PROPOSED FINGAL LANDFILL

Comments
on the
Hydrogeological Risk Assessment

EPA Oral Hearing

27th April 2009

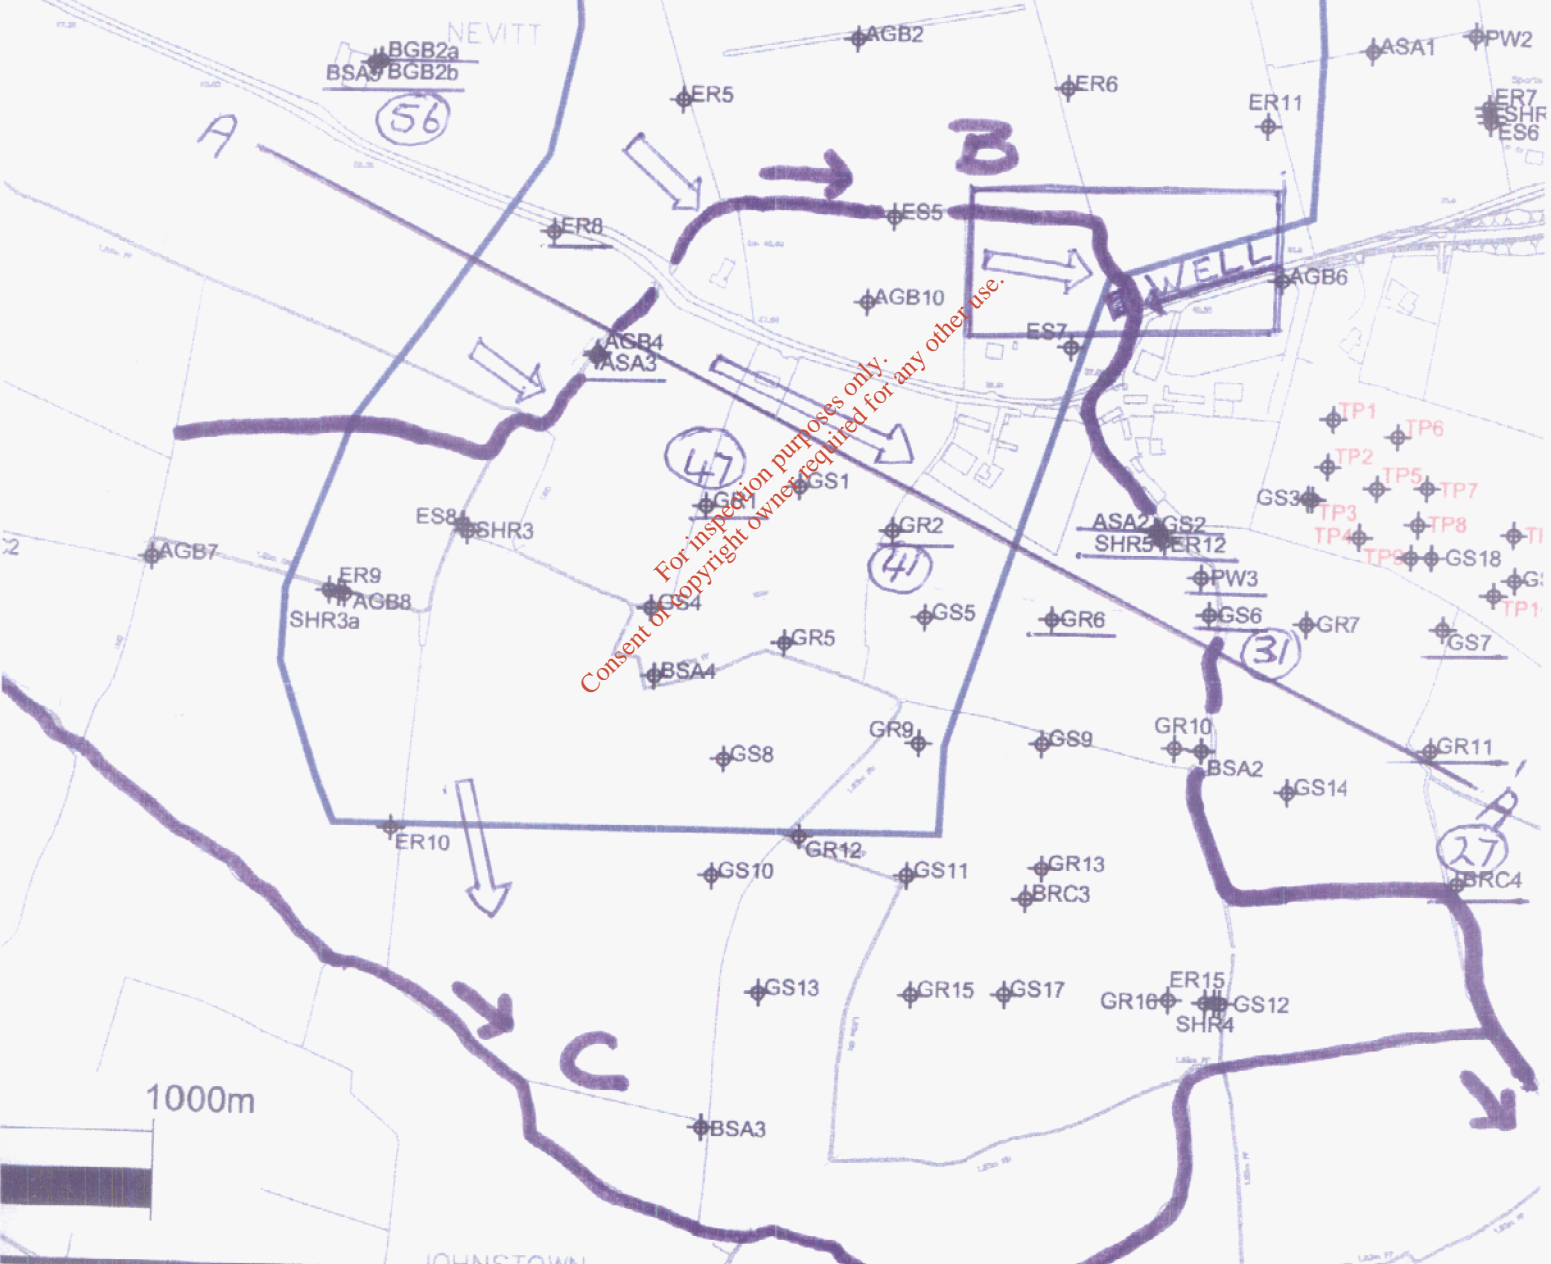
The HRA conceptual model is over simplistic in that it fails to recognize that the movement of groundwater in the clays is likely to mirror the local topography. For example shallow groundwater in the south will exit the landfill site in a southerly direction i.e. in the direction of Kerrigans well.

No analysis whatsoever of the risk posed to Kerrigans horticultural well has been carried out by the HRA. For example the extent of the cone of depression formed during continuous operation of the 1.2ML/Day pump has not been determined, nor the soil conditions at Kerrigans well.

SITE MAP
LATERAL FLOW
IN SATURATED CLAY
AVERAGE GROUNDWATER
LEVELS IN CLAYS
LONG SECTION A-A'

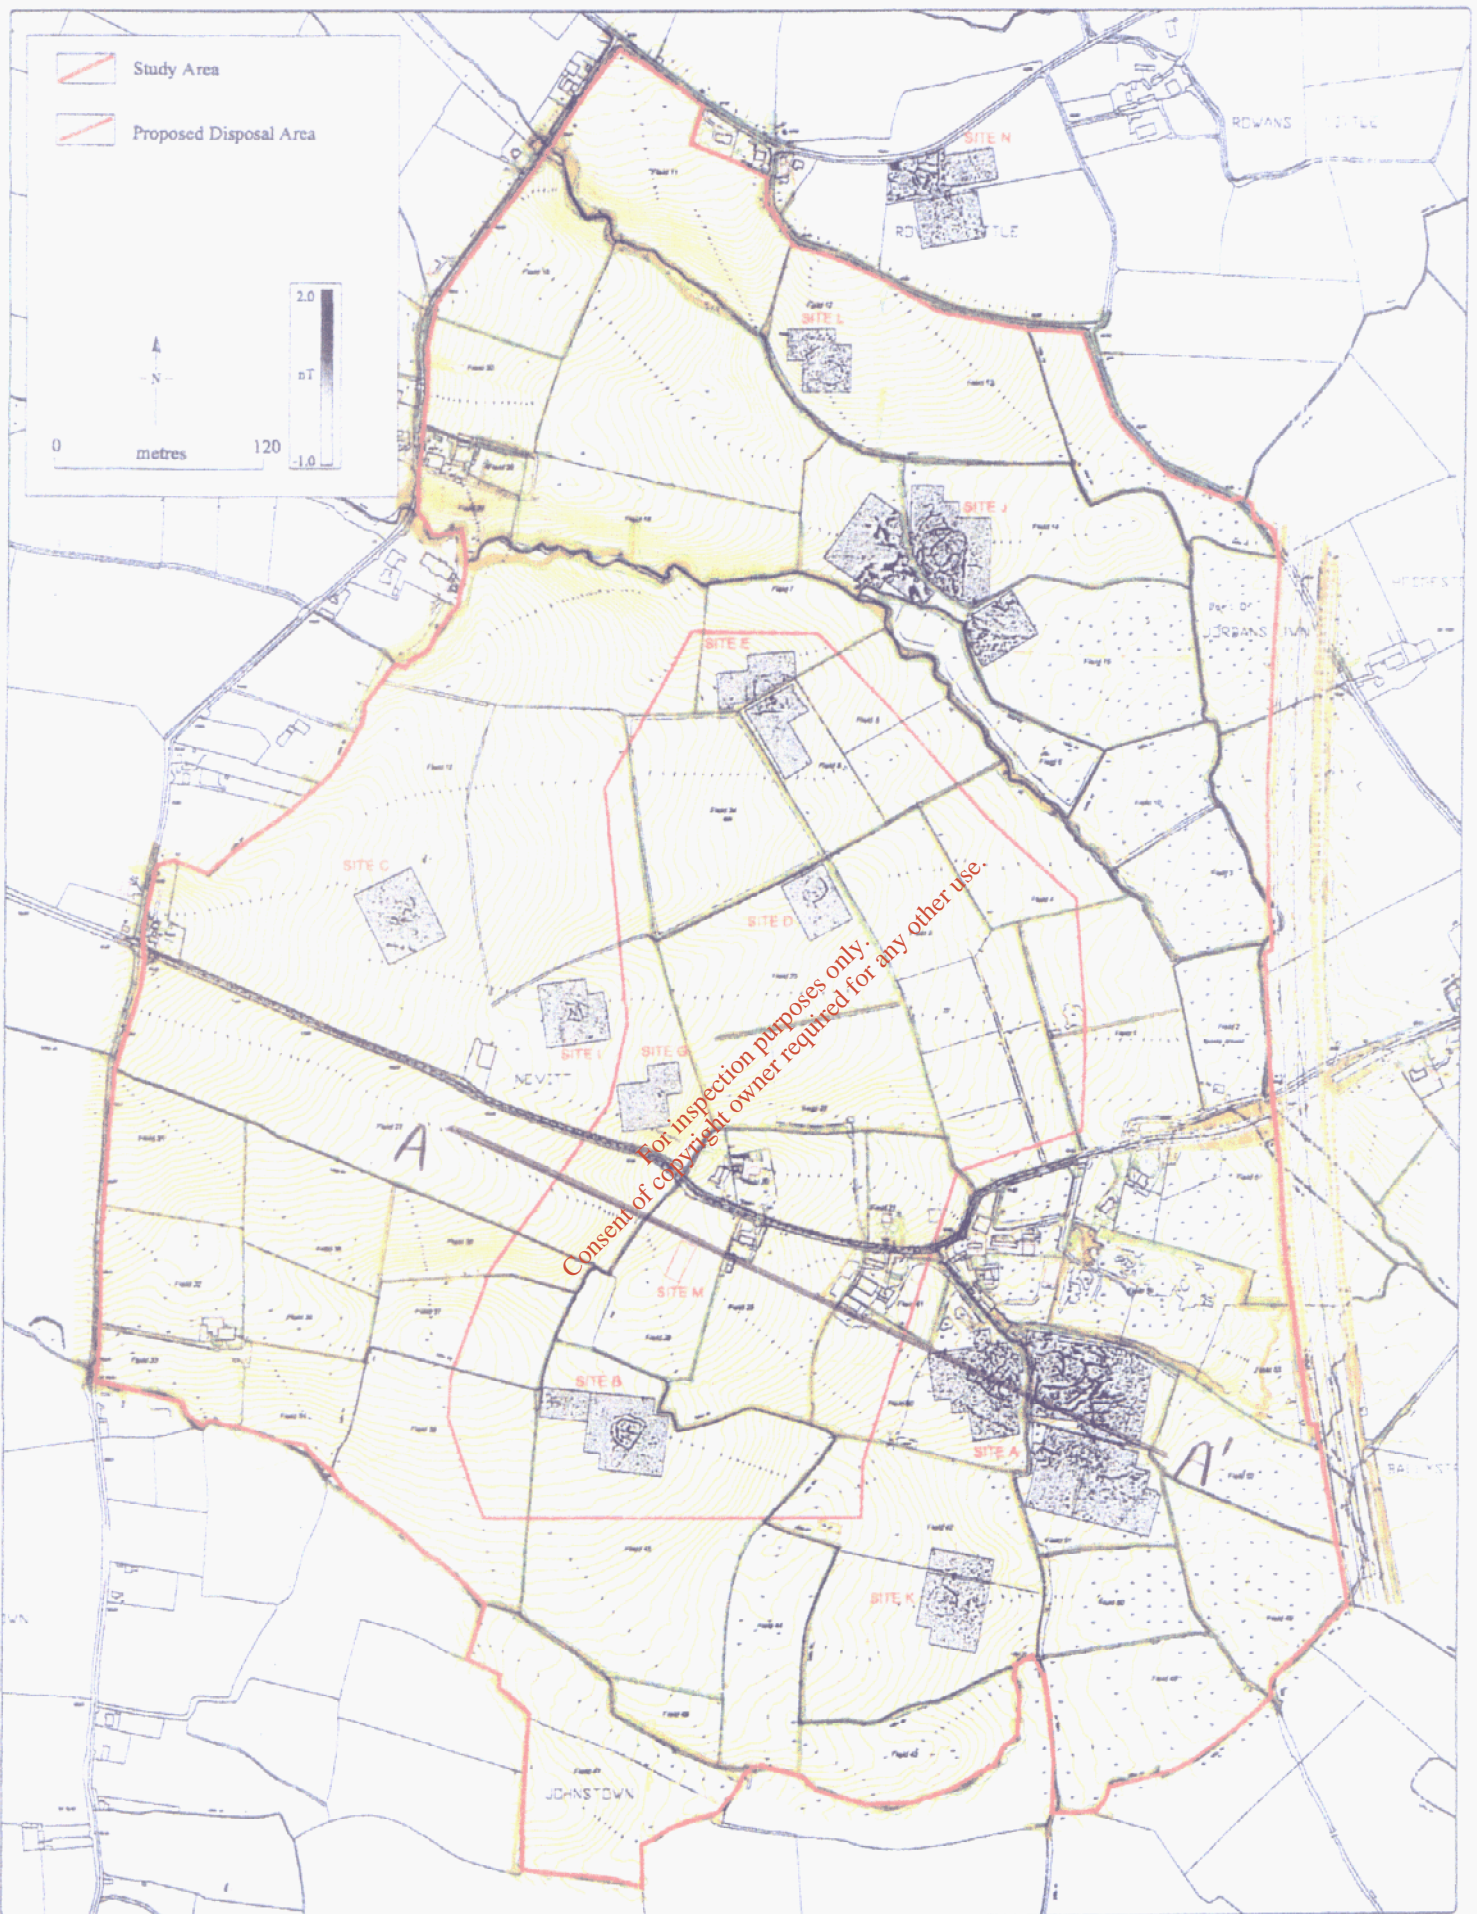
The shallow groundwater adjacent to the north, east, and south boundaries of the proposed site lie only a short distance and up-gradient to surrounding streams (marked A,B and C on the attached Site map). Recharge of the streams through saturated clay is thus likely, but this possibility was ignored in the HRA.

The NLAG has recently located a disused well which, until fairly recent times, was the principal source of water for the residents of the Nevitt. (see attached site map). The well lies within the deep ditch containing the stream marked **B** and is surrounded by a concrete casing (see attached photos). **This stream lies within the landfill footprint.**

The groundwater level in the well, which is the local water table, is the same as that of the adjacent stream i.e. the stream bed is accepting a direct entry of groundwater from the landfill site. In fact there is clear evidence that the stream bed has been artificially deepened for some distance upstream to facilitate the entry of groundwater.

Borehole data (attached) shows a steep gradient in the clay water table across the site from west to east (see site map, section A-A'). The direction of flow along this section is assumed to follow the topographic contours (see detailed topographic map attached). The Geophysics map Depth to Bedrock along this section shows that the depth varies from ~8meters up-gradient of the site, to ~30 m below the site, to ~8 m down-gradient to the east.(see attached map). The down-gradient section is characterised by shallowing gravels – eventually 5m below ground level at BRC4- directly overlying bedrock. The HRA failed to note that 10

Figure **21.2**

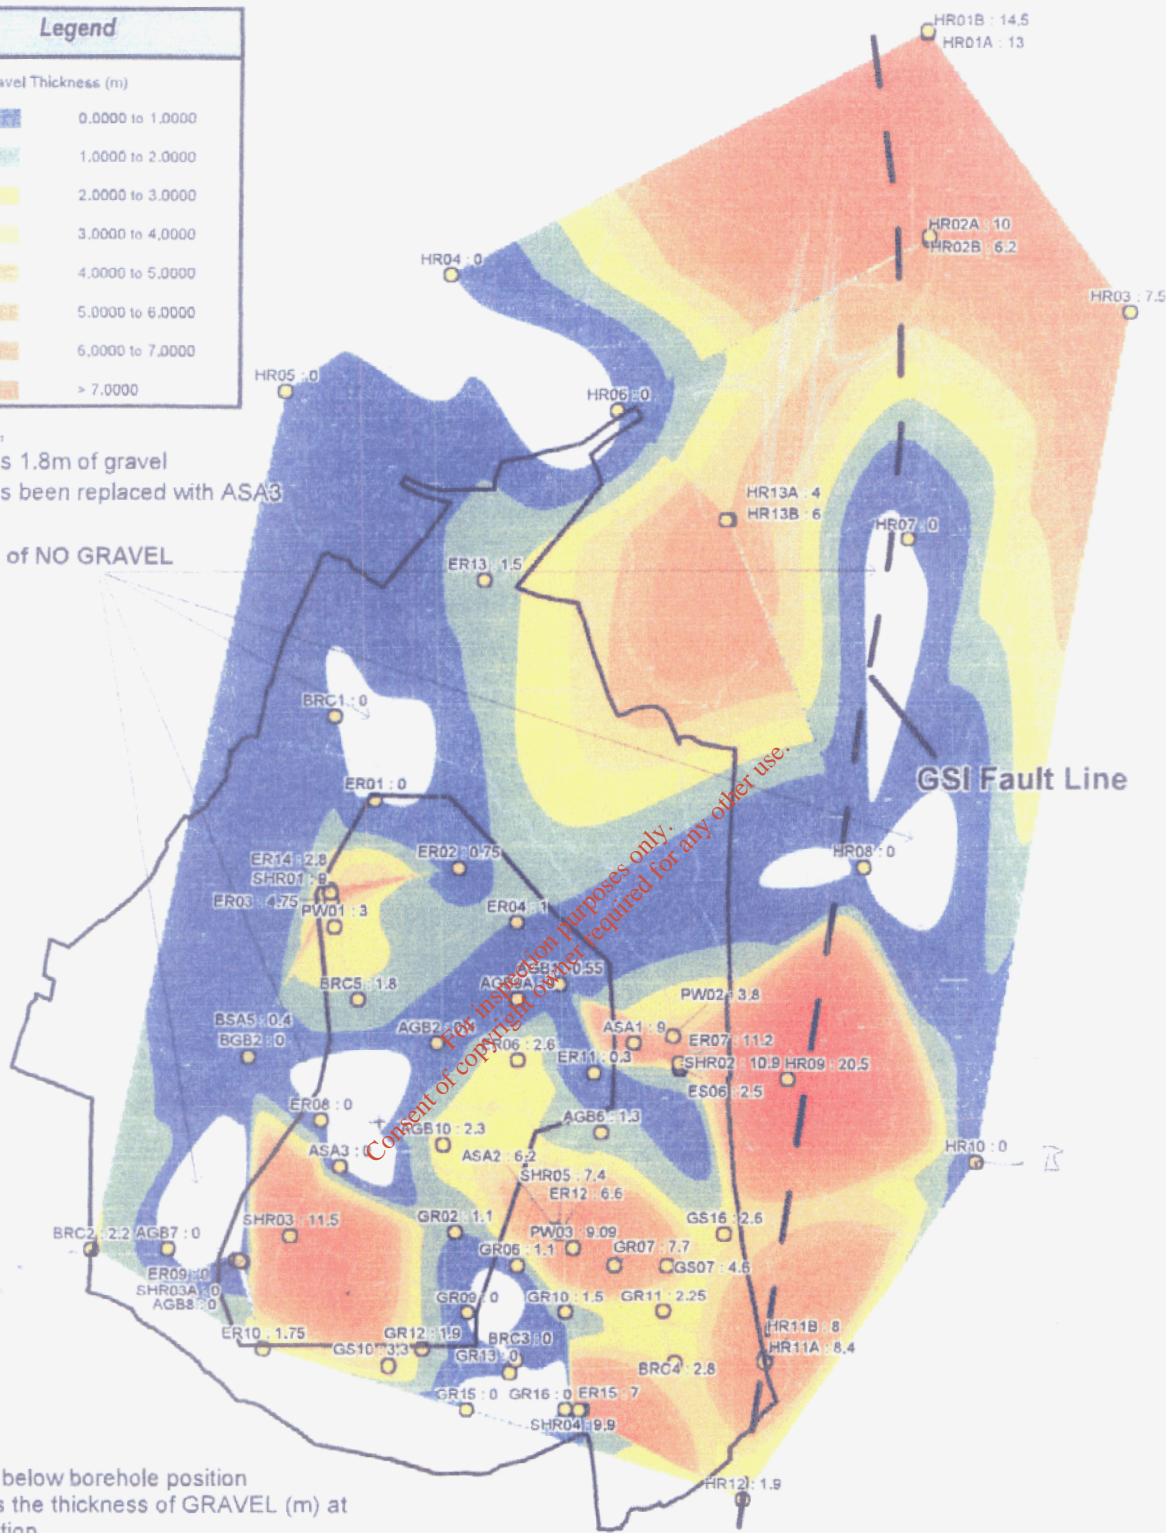
metres of clay is no longer present in this down-gradient area and that a geological barrier is absent.(see Gravel Map and BRC4 borehole data).

Changes,
BRC5 has 1.8m of gravel
AGB4 has been replaced with ASA3
